138 – 140 Highgate Road, Camden Construction Dust Monitoring Plan

Status: Final Date: 30.06.2020

Author	Christine Park Senior Environmental
	Consultant
Approved By	Grokam alarry
	Graham Parry Managing Director
Report For	Daniel Woolfson Unit 13 Old Dairy Court 17 Crouch Hill London N4 4AP In respect of the discharge of Condition No.29 (Ref.
	2019/4335/P)
Date	30.06.2020
Version Number	A3744/DMP/01
Status	Final

Figure 3.1: Dust monitoring locations

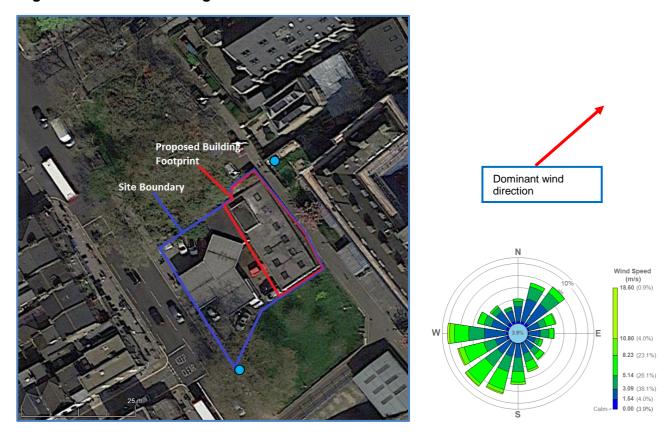
In terms of the locations of the monitors shown in figure 7.1 you are advised that more than 2 monitors should be installed around the side to monitor the dust – at least one on the down wind and at least one on the up wind (to capture dust). The top monitor location identified in figure 7.1 would monitor and deal with dust next to residents next to northwest/southwest section but one should also be installed at the bottom of the site next the pavement as people could be walking past the site during the construction phase.

- 1. No rational for siting of the monitors (no evidence for wind direction, no reference back to original sensitive receptors, no identification of the main sources of dust from the scheme)
- 2. Need to demonstrate that the positions (as well as locations) are suitable and meet the IAQM guidance to avoid obstruction of the monitors
- 3. Confirmation that there needs to be at least 2 monitors
- 4. These monitors need to be installed at least 3 months before construction starts to ensure a baseline of data monitoring (otherwise you aren't comparing like for like and aren't comparing different seasons). If this cannot be done we need to understand why and what date monitoring is possible
- 5. Proposed monitor brands need to show they are compliant with the London Plan guidance (this needs confirmation). We need the specific models and what would be used 30.06.2020 Page | 4

6. Evidence that proposed positions are suitable."

The proposed air quality monitoring locations (represented by a blue dot  $\bigcirc$ ) are shown in **Figure 3.1** below. The monitors would be at a height such as to ensure that particulate capture was indicative of exposure on the footpath alongside Highgate Road and Dunster House to the northeast of the site. The locations have been chosen using Google mapping and reviewing the meteorological wind rose for London (shown in **Figure 3.1**) and the monitors would be attached to street lamp columns. Where site inspection indicates that monitoring at these positions may be problematic then alternative locations would be agreed with the Council.
